Re: REQUEST FOR ADDITIONAL INFORMATION UNIVERSITY OF FLORIDA TRAINING REACTOR DOCKET NO. 50-83

**REQUEST FOR ADDITIONAL INFORMATION
UNIVERSITY OF FLORIDA TRAINING REACTOR
DOCKET NO. 50-83**

(November 26, 2008)

Figure 2 schematic of UFTR secondary coolant system used for determination of heat exchanger inlet/outlet pressures.

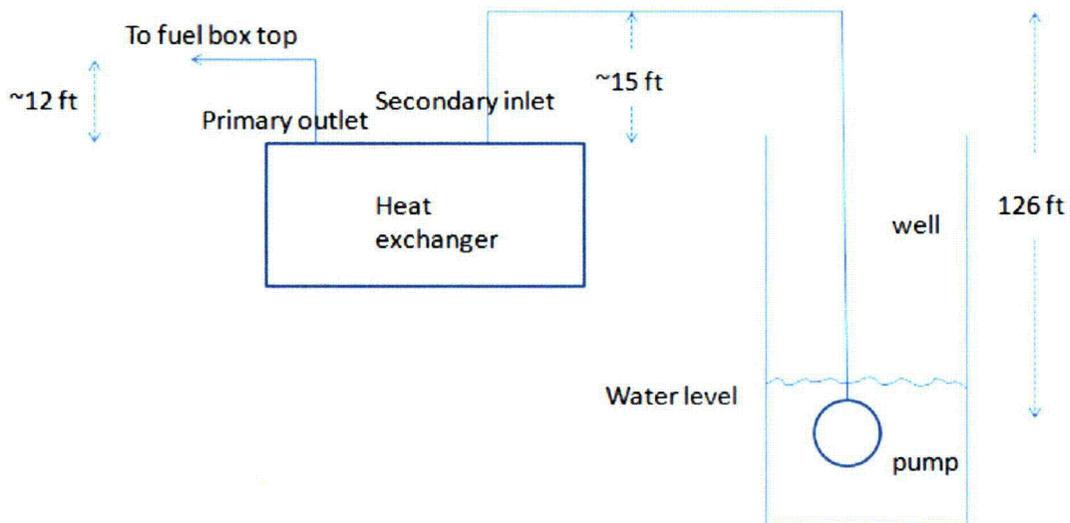
Is the assumption that a significant leak would be detected in the primary water resistivity valid if the reactor is operating at the TS limit of 36 gpm or 41 gpm primary flow rate (or normal primary flow rate if it is in excess of the allowed TS limit) and 60 gpm or 8 gpm secondary flow rate? In your response, address how the primary and secondary pressures are affected by the flow characteristics in the heat exchanger.

The heat exchanger shell-side and tube-side inlet/outlet pressures are not monitored in UFTR. However, we can estimate the pressures based on the piping layout and pump characteristics. Figure 5-5 in UFTR SAR shows the schematic of UFR secondary coolant system. The figure is also attached in this document (Appendix A). A simplified version of Figure 5-5 in SAR is used here to estimate the primary outlet and secondary inlet pressures as shown in Figure 2

the height difference between the pump and heat exchanger is ~111 ft (126 ft minus 15 ft). Assuming no significant pressure loss in the pipes, the secondary inlet pressure is about 50 ft (163 ft minus 111 ft) water above the atmosphere pressure. While on the primary side, the height from the heat exchanger to the top of fuel box (where the pressure is atmosphere) is ~12 ft. The primary outlet pressure is about 12 ft water above the atmosphere pressure. Considering 1 psi is equal to 2.306 ft water, then the inlet pressure for the secondary is ~36.4 psi, and the outlet pressure for the primary is ~19.9 psi. Considering the expected pressure drop in the heat exchanger give in Table 2, the secondary outlet pressure is ~34.2 psi, which is ~72% higher than the primary outlet pressure. This difference increases as the secondary flow rate decreases, e.g., at 100 gpm with a dynamic head of 238 ft, the pressure difference is ~251%. This means that there is always a negative pressure which prevents any leak from the primary loop to the secondary loop.

Figure 1 - Comparison of the activity release for different operation time as a function of sodium concentration (100 kW, 1 liter/hr, 60 gpm)

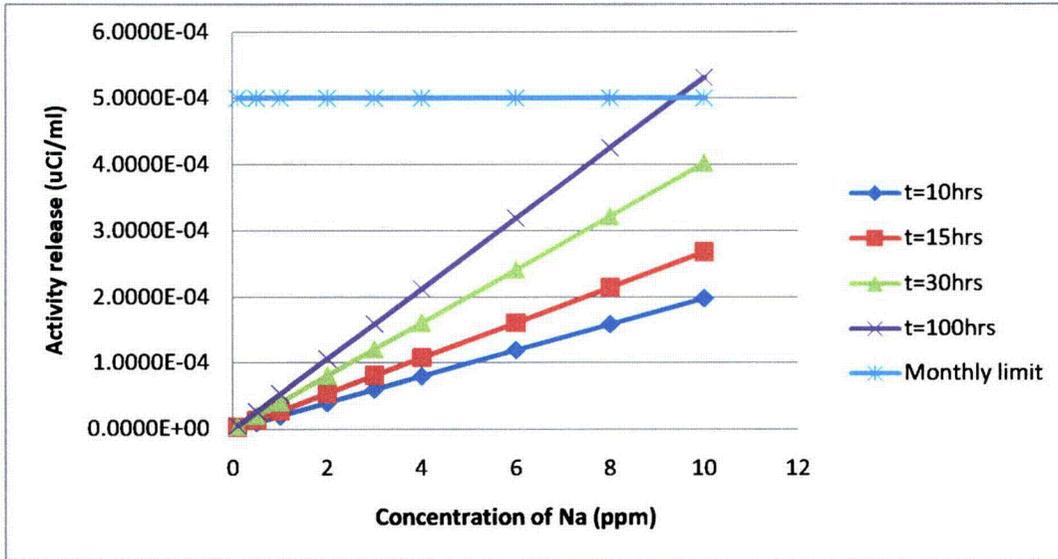
Question 2a: *What is the basis for the ‘assumptions of 1 ppm sodium in the primary coolant, activation for 10 hours, and 1 liter/hour leak rate for 1 hour?’*

Above figure indicates that the activity is less than the monthly limit if sodium concentration is less 9 ppm even at an unrealistic case of 100 hrs of operation. Only, for cases with concentrations between 9 ppm and 10 ppm the concentration exceeds the limit for the 100 hrs operation case. Further, this diagram indicates at a more realistic value of Na concentration of 1 ppm and operation time of 10 hrs, the activity release is less than the limit by a factor of ~25.

Figure 3 - Comparison of the activity release for different sodium concentrations as a function of secondary flow rate for 1 liter/hr leakage (operation time of 10 hrs, 100 kW).

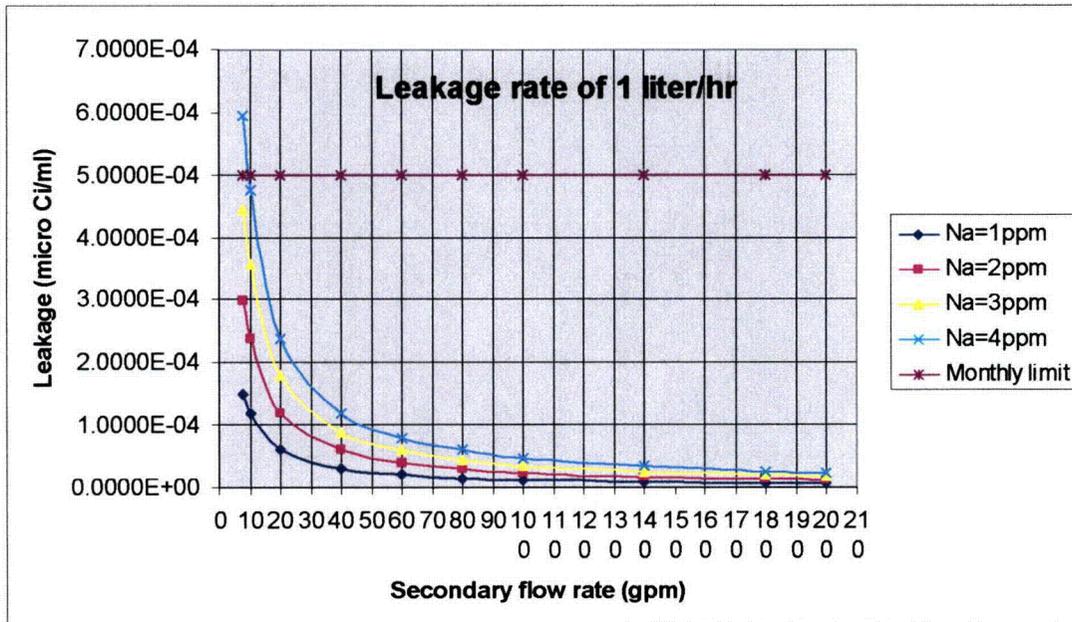
Question 2c. *As discussed previously, the TS limit on secondary flow rate is 60 gpm when using well water and 8 gpm using city water. Therefore, provide an estimated effluent concentration assuming the allowed TS limits for secondary flow.*

Above figure indicates even if the secondary flow is as low as 8 gpm, the leakage activity is less than the limit for Na concentrations of up to 3 ppm. If the secondary flow rate between 100 gpm to 200 gpm, where the latter is the nominal value, for a more realistic Na concentration of 1 ppm, the leakage activity varies in the range of 1.2×10^{-5} to 6×10^{-5} which is significantly smaller than the limit by a factor of ~40 to ~100.
